Subject: License No. SUB-1010, Docket No. 040-08027
Reclamation Plan Acceptance Review, Request for Additional
Information

ENCLOSURE 1
Sequoyah Fuels Corporation
Reclamation Plan Acceptance Review
Request for Additional Information

SFC Responses to Request for Additional Information
August 8, 2003

ENCLOSURE 1
Sequoyah Fuels Corporation
Reclamation Plan Acceptance Review
SFC Responses to Request for Additional Information

Figure 3.1 Geologic Provinces of Oklahoma (From Northcutt and Campbell, 1995)

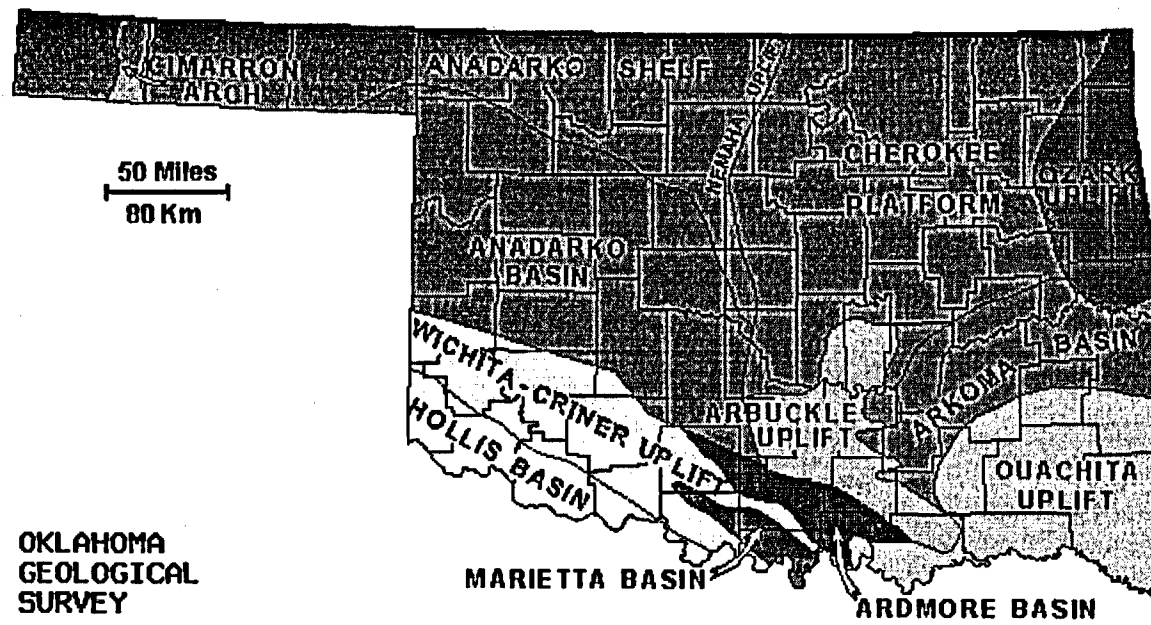
- S1. Provide an updated listing and a map (up to the present) showing the earthquake distribution within 200 miles of the site.

As shown on Figure 3.1 of The revised Appendix E of the Reclamation Plan, the SFC Facility is located at approximately the contact between three tectonic provinces: (1) the Ozark uplift, (2) the Cherokee platform, and (3) the Arkoma basin. The Black Fox Nuclear Power Plant (NPP) site is within the Cherokee platform tectonic province.

FIGURE 3.2
FAULTS WITHIN FIVE MILES RADIUS OF SITE
 (ADAPTED FROM FIGURE 9 OF FRI, 1997 AND VAN ARSDALE, 1998)

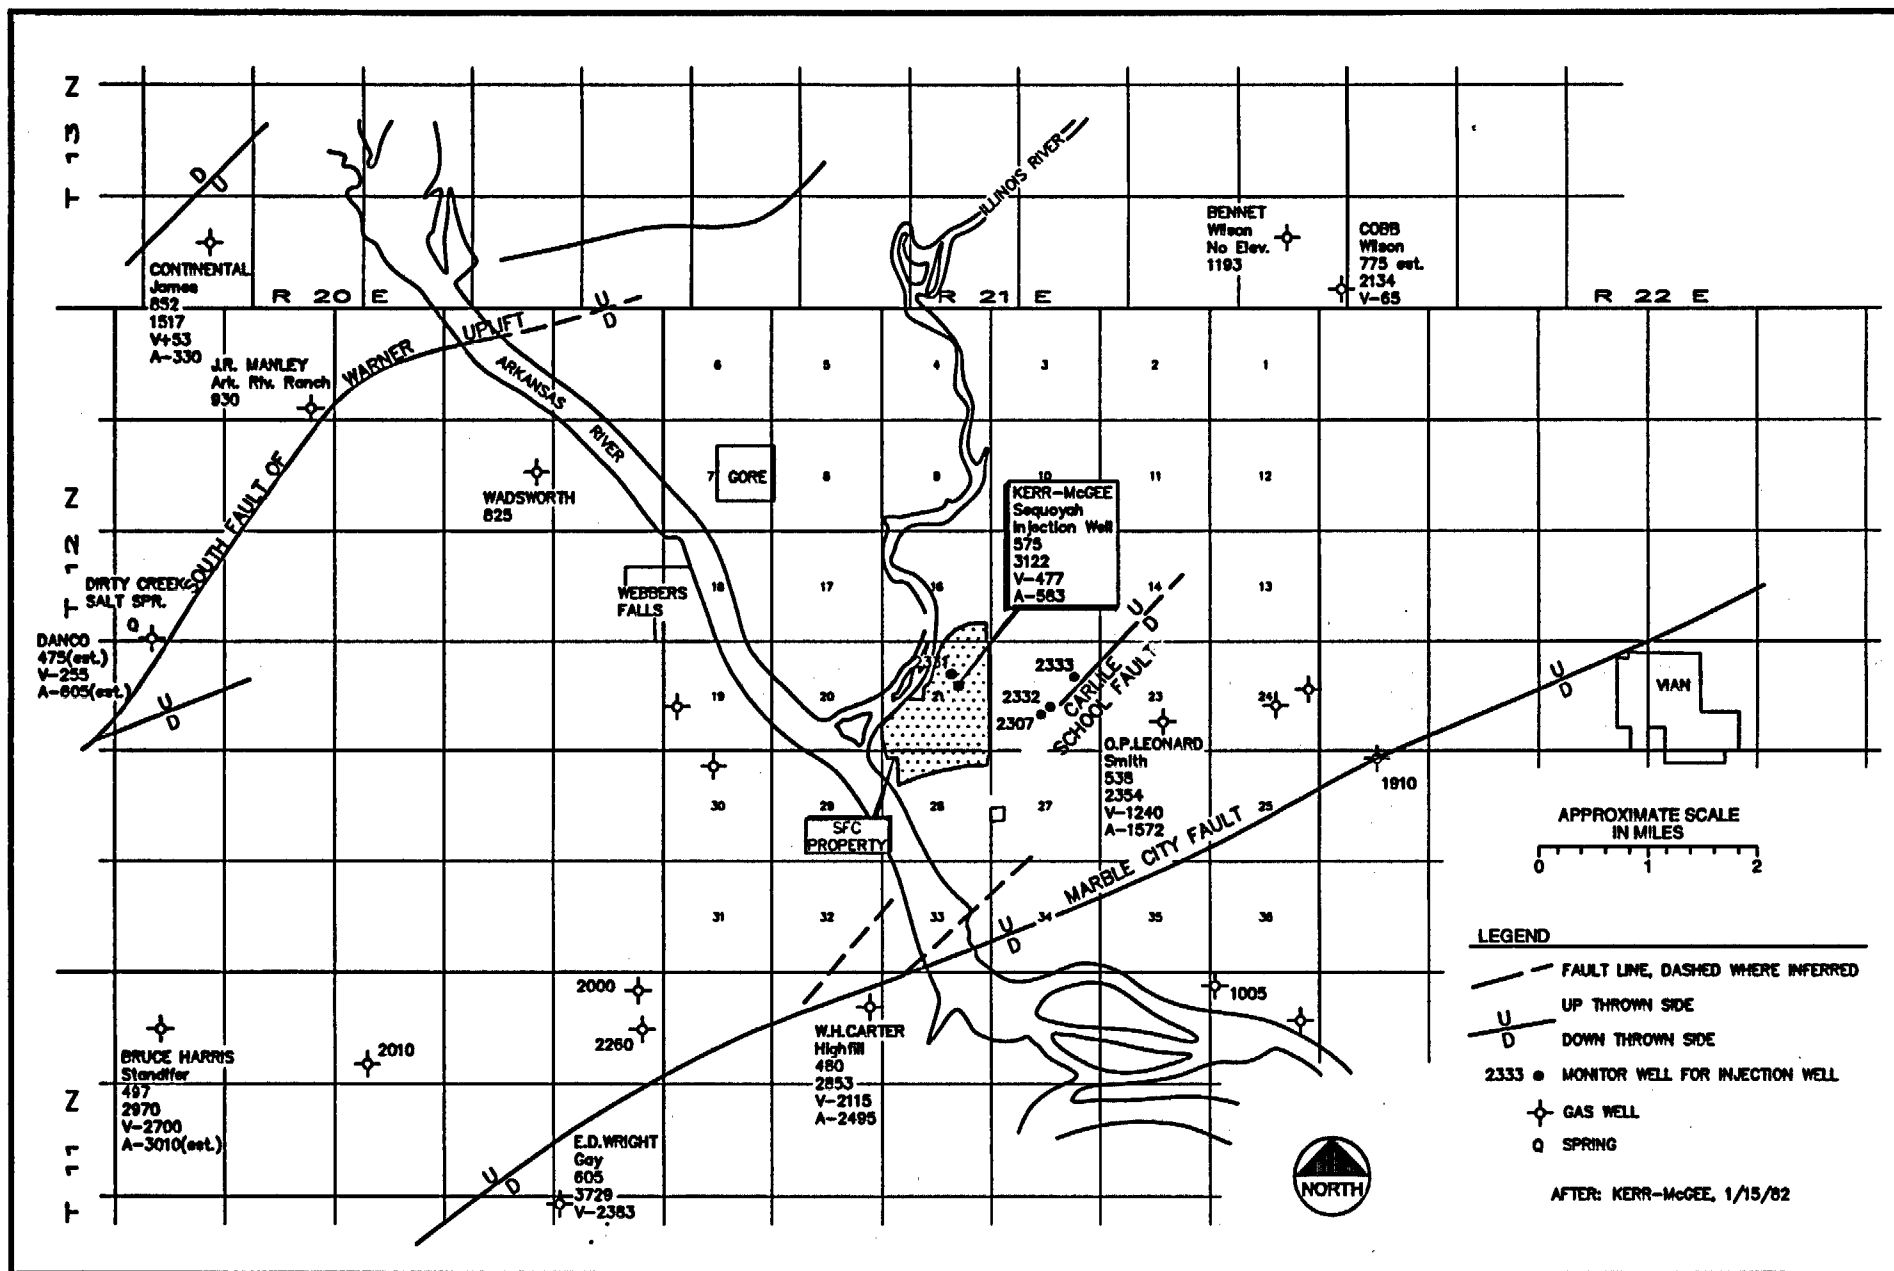
- G1. *Requirement to account for potential capable faults [criterion 4(e) of 10 CFR 40, Appendix A].* Please provide information to demonstrate that SFC has investigated and analyzed known and potential faults within 200 miles of the site that might be capable faults. The following types of information should be provided for each potential capable fault: name, location, length, distance from site, evidence that it is a capable fault (see 10 CFR part 100, Appendix A), evidence of the frequency and amount of displacement, and age of last movement. The investigation should seek to discover and include up-to-date information concerning potential capable faults, such as recent geological maps, geophysical surveys, and seismicity maps.

Figure 3.2 shows all known faults within 5 miles of the SFC Facility, as presented in SFC (1997b). These faults include: (1) the Marble City Fault and its splay (MCF), (2) faults associated with the South Fault of Warner Uplift (SFWU), and (3) the Carlile School Fault. NRC concluded that none of these faults are capable faults (NRC, 1998a), as discussed below.

FIGURE 6.1
FACILITY TOPOGRAPHY MAP

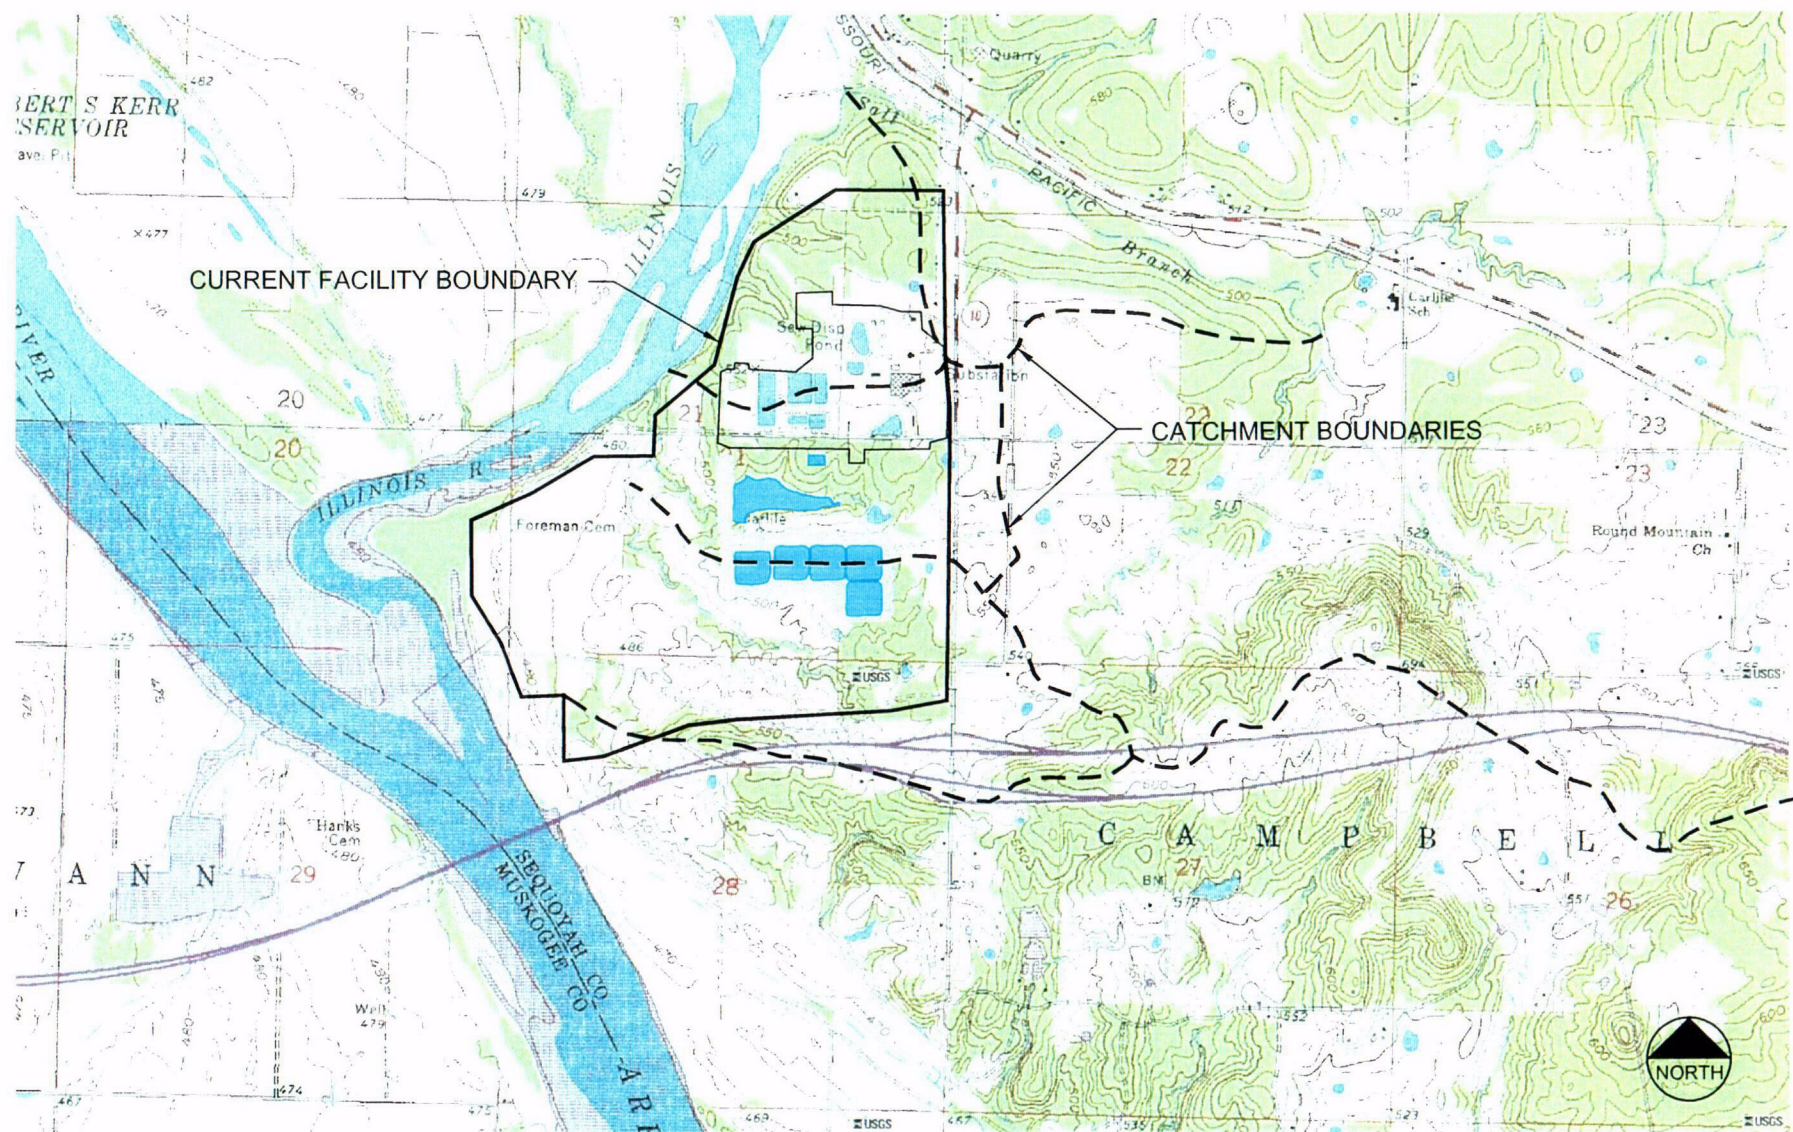
- SW4. Provide maps and/or drawings delineating sub-basins on and near the impoundment.**

This basin delineation map is provided in Section 6 of the revised Appendix E of the Reclamation Plan.

The SFC site is located above the east bank of the Illinois River at its confluence with the Arkansas River. The site is on the western end of a broad upland area approximately 100 feet above the normal elevation of the Illinois River (as impounded by the Robert S. Kerr Reservoir). The regional topography is shown in Figure 6.1 (from SFC, 1998a). The drainage basin boundaries for the site area are delineated on the figure.
